Rezoning Transportation Analysis

Petition Number: 2018-078

Date	Description
07-13-18	First Review

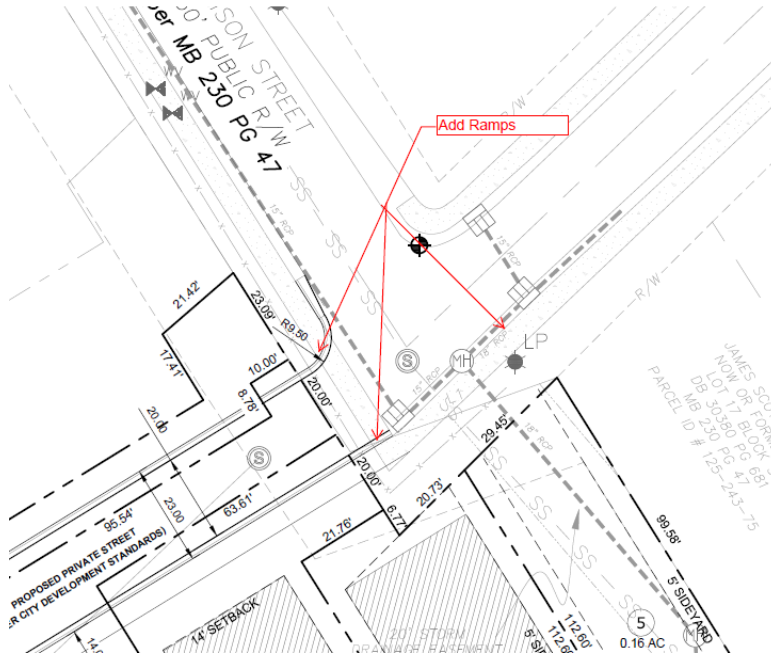
1. **Traffic Study** A Traffic Impact Study/Transportation Technical Memorandum is not necessary for the complete review of this petition.
2. The petitioner should revise the site plan and conditional note(s) to show 8' planting strip and 6' sidewalk around the proposed private street.

- The petitioner should revise the site plan and conditional note(s) to improve intersection where proposed street is to be extended to include ramps at the remaining corners.

- The petitioner should revise the site plan and conditional notes to show 8' planting strip and 6' sidewalk along the private street.
- The petitioner should revise the site plan to add a note specifying dedication and fee simple conveyance of all rights of way to the City before the site's first building certificate of occupancy is issued. CDOT requests right of way set at 2' behind back of sidewalk where feasible.
- The petitioner should revise the site plan to add a note specifying all transportation improvements will be approved and constructed before the site's first building certificate of occupancy is issued. The petitioner may phase transportation improvements if said improvements and phasing are explicitly described in site plan notes.
- ~~Resolved~~ Sample format for comment that is resolved
